Attention: Amy Robertson Planner Modification Assessments NSW Planning & Environment GPO Box 39 Sydney NSW 2001

Your Reference: MP10_0136 MOD1 Riverside

It is understood that the document on which this submission is based is a Modification to the Concept Plan, this Plan having been approved on 27th June 2013.

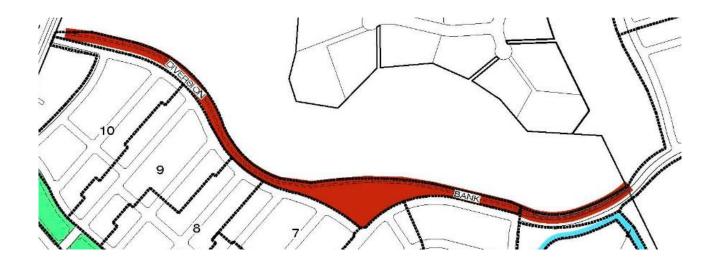
When questioned about the rationale for this decision the Sheargold presenter was unclear as to their intentions for future use of the area - one of the many decisions set aside by the developer for *later-on*.

✓ all that can be learnt from maps provided is that this area is not part of the approval,

- it fronts the Myall River and supports a private residence involved with the development.
- ✓ it is noted from Fig 6 that the dwelling on this particular property has access to a public road in the Shearwater estate, access to which will be obliterated by development works.
- ✓ it would seem necessary that the intent for this location be determined before final development approval.
